780-001-11

ADDENDUM NO. 2

Project: Freeman Public School Improvements
 Adams, Nebraska
 Project Number: 780-001-11
 Owner: Freeman Schools
 Meeting Date: October 2, 2012

Addendum #02
 Supplemental Drawing: SDA-010
 Revision of Sheet: A1.00
 Date: 10/03/12

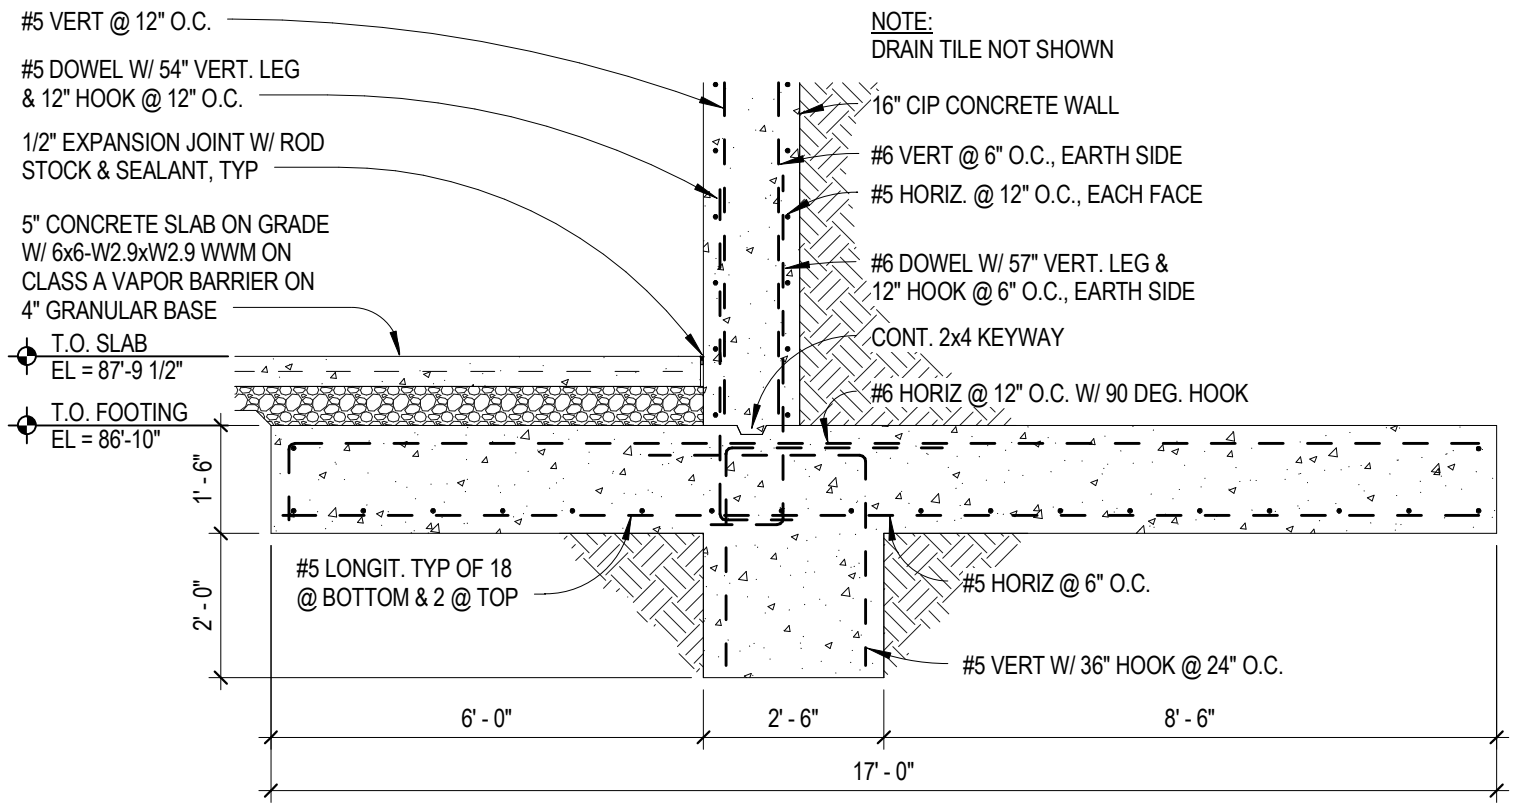
- a. Refer to door 017; change door and frame to be double egress passage. Refer to Supplemental Drawing SDA-10.

- a. Refer to doors 007.1; change the fire rating to 60 min.
- b. Refer to doors 007.2; change the fire rating to 60 min.
- c. Refer to door 017; change door and frame to be double egress passage, fire rating to 90 min.
- d. Refer to door 108; change the fire rating to 90 min., provide hardware set 9.0 (in lieu of set 14.0)
- e. Add door number 110.1 to door schedule; rolling counter door size at Concessions 110 is 12' wide x 4' tall.

ALTERNATE TO SECTION DETAIL #18/S3.01

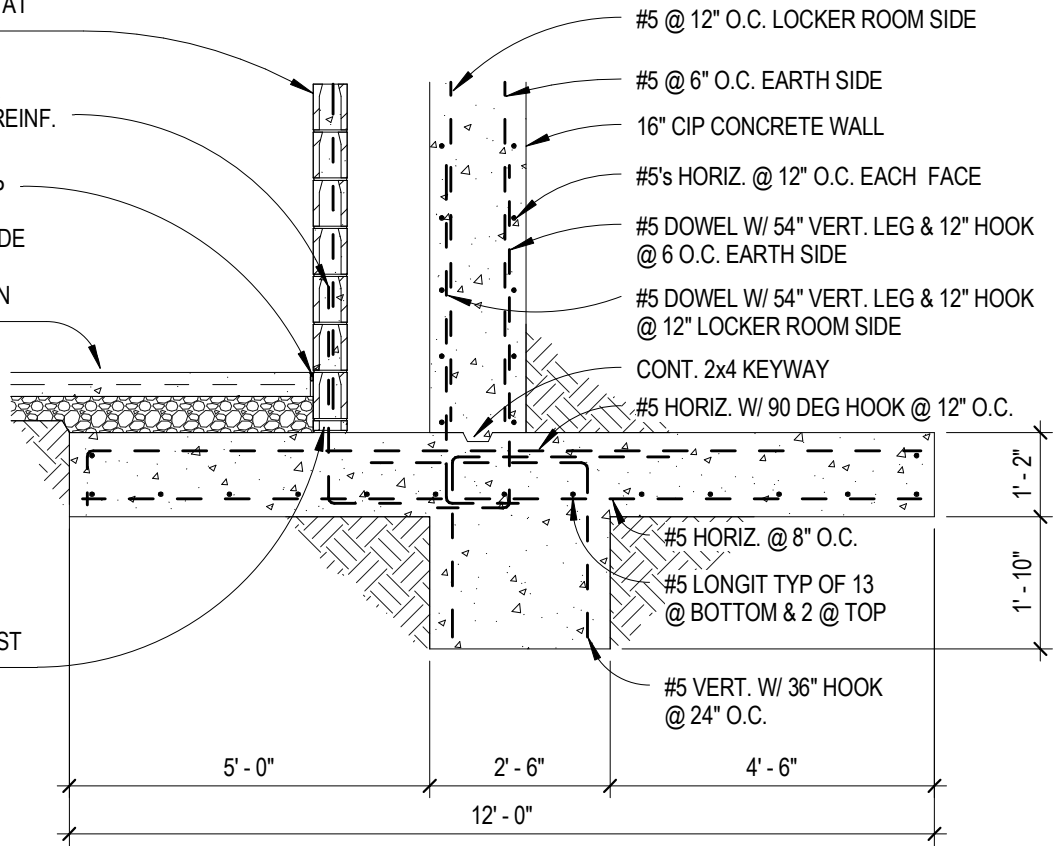
Refer to section 3.1 – Schedule of Alternates. Add Alternates S-2. Submit a cost to provide and install footings and cast in place concrete walls as shown on Details 4 and 5 on Sheet S3.02 at walls adjacent to Grid 12, in lieu of the footing and walls shown on Details 17 and 18 on Sheet S3.01.

Add Details 4 and 5. Reference attached Supplemental Drawings SDS-002 and SDS-003.
